<p>Comment(s) received:</p> <p>From: s.16 Planning Application A/YL-NSW/352 - Departmental Comments (DPO) Date: 26 Aug 2025 & 11 Sep 2025 Project: YL-240431</p> <p>Comment(s):</p>	<p>Date of response: 2 Sep 2025 Date of supplementary information: 11 Sep 2025</p>
<p>1. According to the submitted Supplementary Information on 25.7.2025, it is noted that there is a power supply circuit currently operating at the Site. Please clarify the location of the existing power supply circuit as well as the time period of which it has been in operation at the Site.</p>	<p>There is a power supply circuit currently operating at the site for the sole structure (blue dotted line) consists of the lots: <u>DD104 LOT3719 s.J ss.1 s.A RP</u>; <u>DD104 LOT3719 s.J ss.2 RP</u>; <u>DD104 LOT 3719 s.J ss.4 RP</u>; <u>DD104 LOT3719 s.J RP</u>; & <u>DD104 LOT3719 s.Q ss.1 s.C RP</u>. Since the owner of the premises would like to split the current sole structure into 2 portions and applied a new power supply from CLP for the proposed development under the lot D.D. 104 Lot 3719 s.Q ss.1 s.C R.P., where the applying additional power supply will be over the capacity of current circuit. Additional power cables are

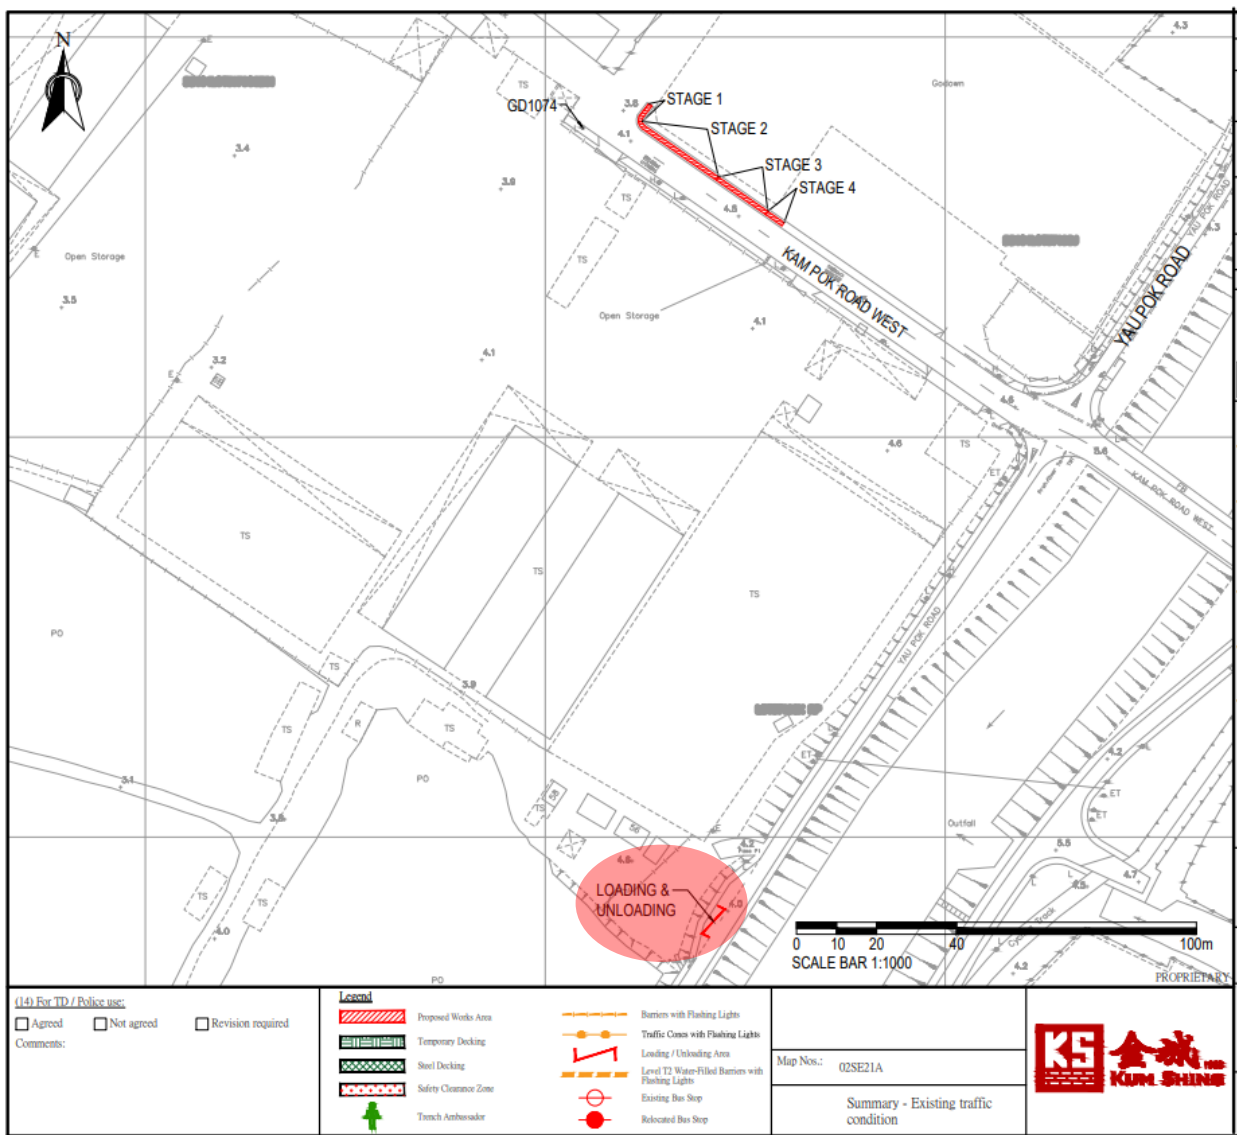
2. Please provide details of the loading/unloading arrangements in the application.

The proposed loading/unloading point at the nearest lay-by and please refer to below drawing from the TTM:
